# CRASH INJURY EVALUATION

U. S. ARMY HU - 1A

BELL IROQUOIS HELICOPTER

TREC Technical Report 60-73

Figure 2. View of the vertical side supports. Arrow 1 denotes the vertical side support; arrow 2 depicts the aft firewall roof support.

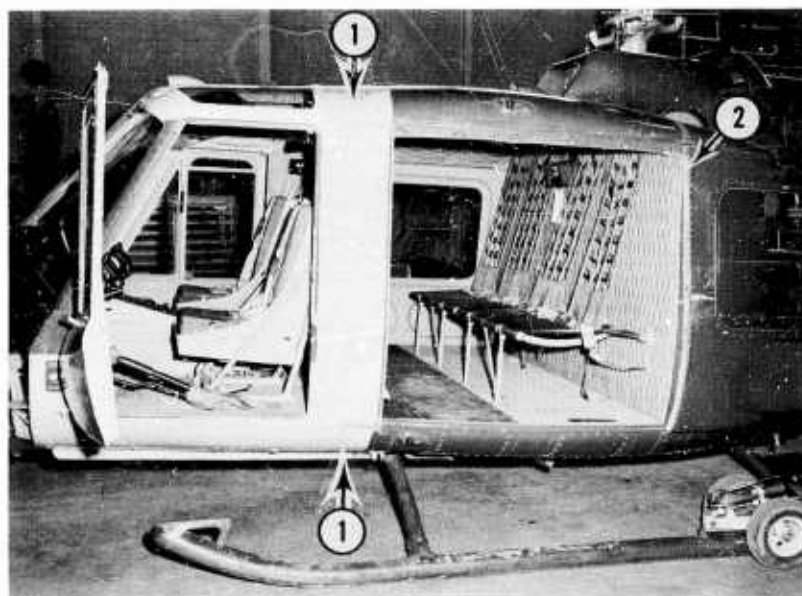
The extreme forward portion of the roof structure of this aircraft is supported by the front door frames and the center strip of the windshield frame structure. The main support is provided by left and right vertical support members shown in Figure 2. The aft end of the roof is supported on a secondary type of structure, the aft firewall bulkhead, also shown in Figure 2.

The lower attachment points of the vertical support members on the right and left side of the cabin consists primarily of two "L" stringers, one fore and one aft. The outer skin of this support extends into the roof structure and is attached to the longitudinal roof support. At the present time, according to the Military Specification, this vertical support is required to carry only a normal air load.

Failure of these main side supports plus the failure of the aft bulk-head support permits the roof structure to lower sufficiently to strike the occupants or the seat backs in the occupiable crew and cabin areas. This is clearly demonstrated by the accident experience where the side vertical supports failed in every one of the five accidents, ranging from partial failure in Accident "C" and Accident "E" to complete failure in Accidents "A" and "D" (Figures 3 through 18). The aft end of the roof also failed in all but one of the five accidents (Figures 19 through 24). Only the absence of forward deceleration probably precluded any forward movement of the aft roof supporting structure in Accident "E".

The Request For Alteration No. 12 in regard to increasing the gauge thickness of the sheet metal structure of the vertical side supports has been approved and is being incorporated into the HU-1B. It is suggested that the second approach, the addition of the roll-over structure, be studied for retrofit of all HU-1A aircraft presently in service.

Figure 34. Over-all view of the instrument panel in the HU-1 and HU-1A. The arrows denote the sharp unprotected lower edges of the instrument panel.

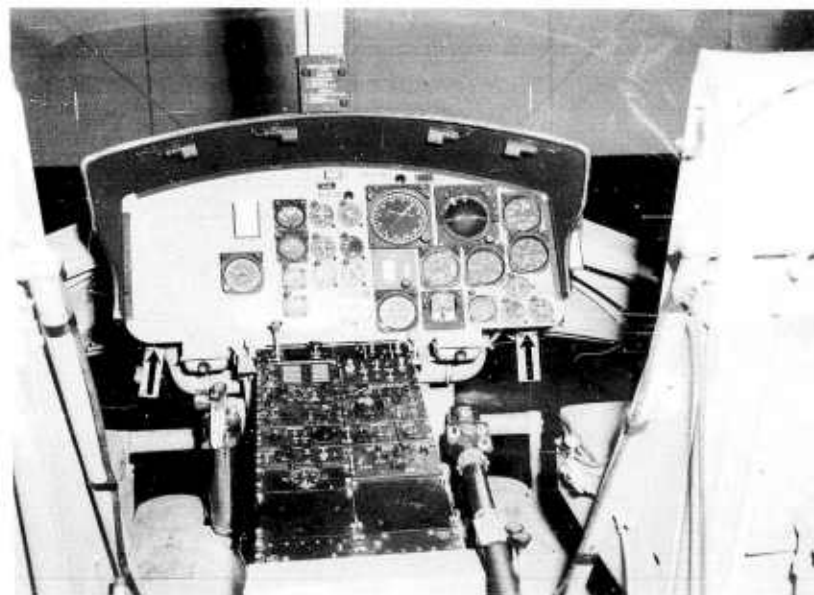
It should be noted that the lower edges of the instrument panel (Figure 34) are quite sharp and unprotected. Statistics reveal that the lower extremities receive the second largest percentage of injuries. The lower edges of the instrument panels should, therefore, be padded with a high energy absorbing material.

Figure 36. Close-up of the safety belt end attachment (arrow). The metal baffle type structure is also depicted.

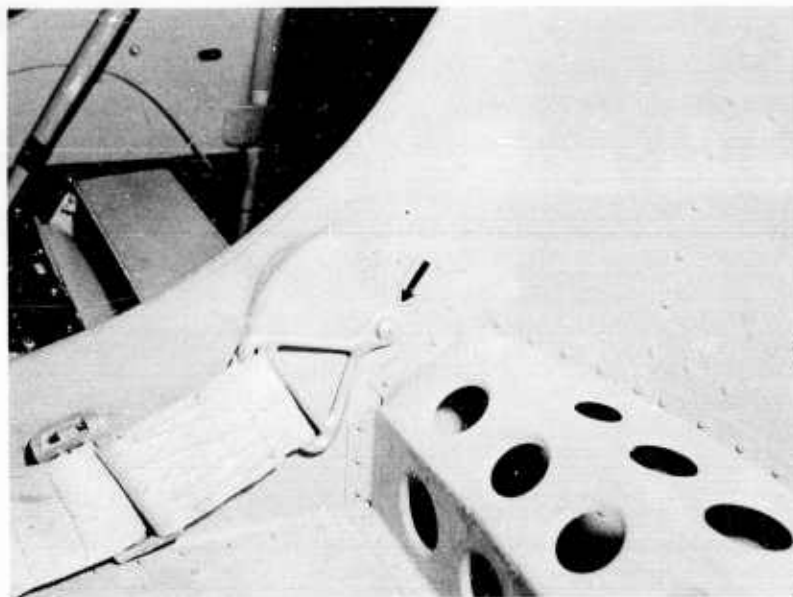
The safety belts on the crew members' seats are attached to the sides as depicted in Figure 36. A reinforcing plate is attached to the outside of the seats for additional strength. It should be noted that this safety belt attachment is not an omni-direction attachment. Helicopters frequently encounter side loads during an accident, and this type of anchorage would have a prying effect on the attachment with possible end attachment failure. It is suggested that the end attachments incorporate a self-aligning omni-directional anchorage.

Figure 47. View of the Crew Chief/Medical Attendant seat mounted in an aft facing position (arrow).

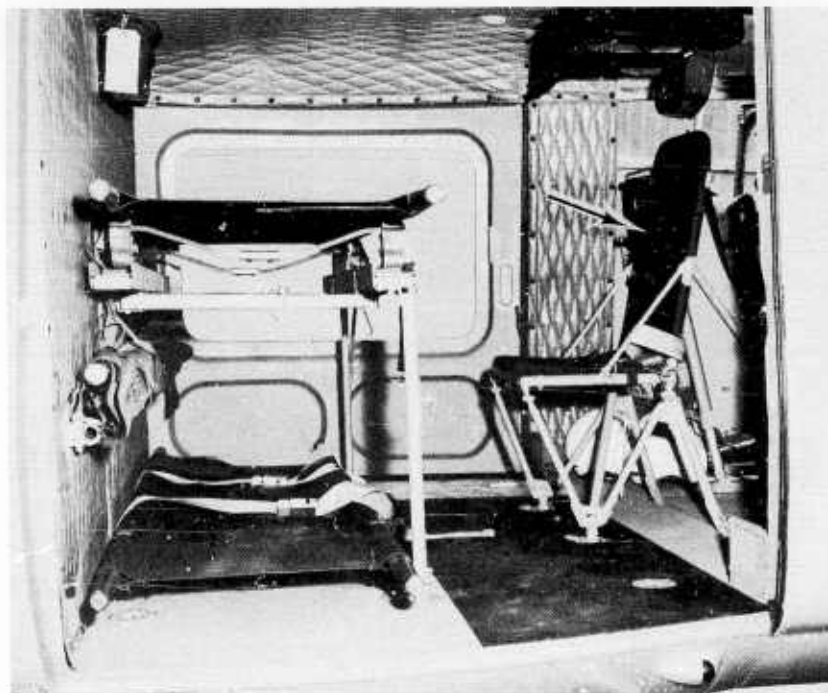
This seat is located just aft of the pedestal and was primarily designed as an aft facing Medical Attendant seat (Figure 47). In some cases the seat is reversed, forward facing, and is utilized by the crew chief. The safety belt is attached at the junction of the seat back and the seat pan and is stressed for 5.0G aft and 10.0G side loads when utilized in the aft facing position.

Out of the five accidents, this seat was installed and occupied only in Accident "D". In this case, the seat was attached facing forward and occupied by the Crew Chief. Upon impact the seat tore free from its leg attachments and permitted the Crew Chief and seat to be hurled out through the windshield.

Figure 50. Cabin seat failure in Accident "C". Arrow (1) denotes the failure in the forward cross-tube. Failures also occurred in the cross-tube which supports the seat back due to the penetration of the transmission (arrows 2, 3).

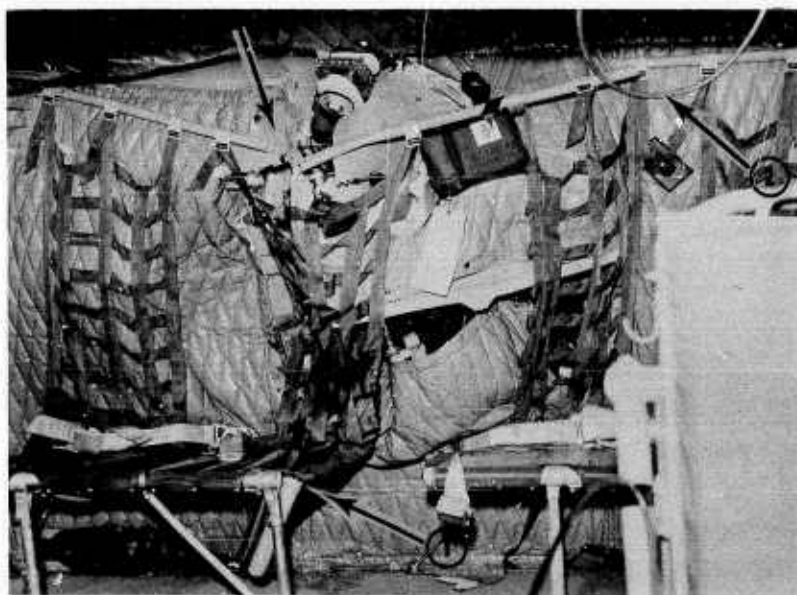
In the five accidents covered in this report, 80 percent of the occupied troop seats sustained either a partial or complete failure indicating an inherent weakness in the seat design. The load-carrying capabilities of these seats are considered unrealistic when an 11G seat bottom is attached to a 1.1G forward seat tube. The testing procedures are also considered inadequate. The following test procedure is quoted from a manufacturer supplying these seats:

Accident experience has proven that MIL-S-5804A requires revision to provide strength requirements compatible with survivable crash force magnitudes, directions, and time duration. Furthermore, the troop seat should be subjected to dynamic testing in order to obtain a more realistic appraisal. The cabin area in Accidents "A" and "B" was unoccupied; therefore, no seat failures occurred. In Accident "E" the seats were folded and replaced with a ferry tank.

Figure 53. The incorrect method of attaching the safety belt to the "O" ring is depicted by the arrow. Note that the belt crosses the occupant at approximately 90°.

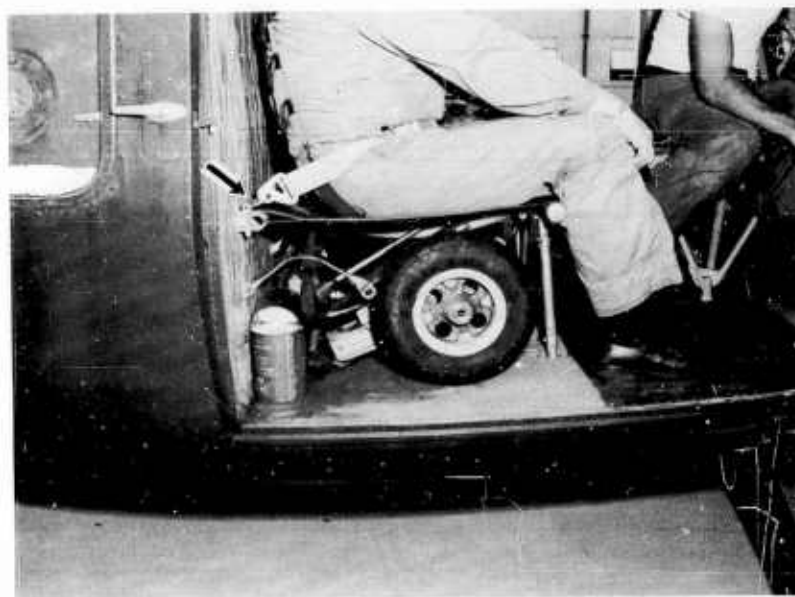
Numerous investigations and evaluations have shown that the cabin occupants' seat belts are being attached to an "O" ring which is attached to a rear longitudinal seat support. The correct and incorrect manner of attaching the seat belts in this aircraft is depicted in Figures 53 and 54.

The belts are stressed to withstand 11.0G at a 45-degree angle upward, forward, and inboard. The seat belts should be attached to the cables which are tied directly into primary structure (Figure 54).

When the seat belt is attached to the "O" ring, Figure 53, the spine is forced to bend or flex at a much higher level which often causes flexion fractures of the spine.

The incorrect belt installation also permits the seat belt to "ride up" and could cause rib and/or chest injuries due to flexing over the belt buckle, in addition to possible spinal injuries.

Figure 56. Absence of exterior door operating instructions. The arrow on the left depicts the interior operating instructions. The arrow on the right denotes the absence of exterior door operating instructions.

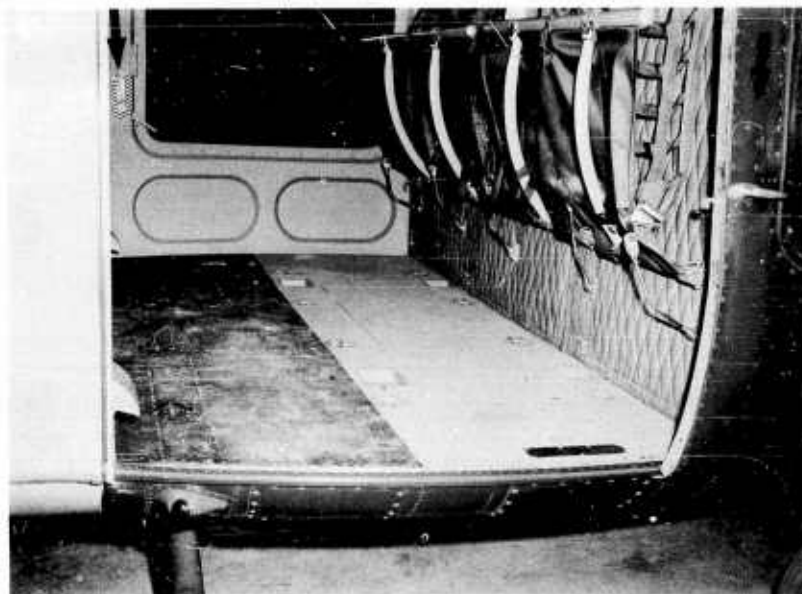
Entrance to the passenger-cargo area is effected by means of two large sliding doors, one located on each side of the aft cabin area (Figure 56).

The large doors permit rapid entrance and departure during combat conditions. In order to prevent inadvertent opening during flight the cabin doors are not jettisonable. In the event of an accident where the doors were rendered inoperable, the large window could be broken or kicked out to provide an avenue of escape. At the present time, however, there are no operating instructions on the exterior of the door to assist untrained rescue personnel.
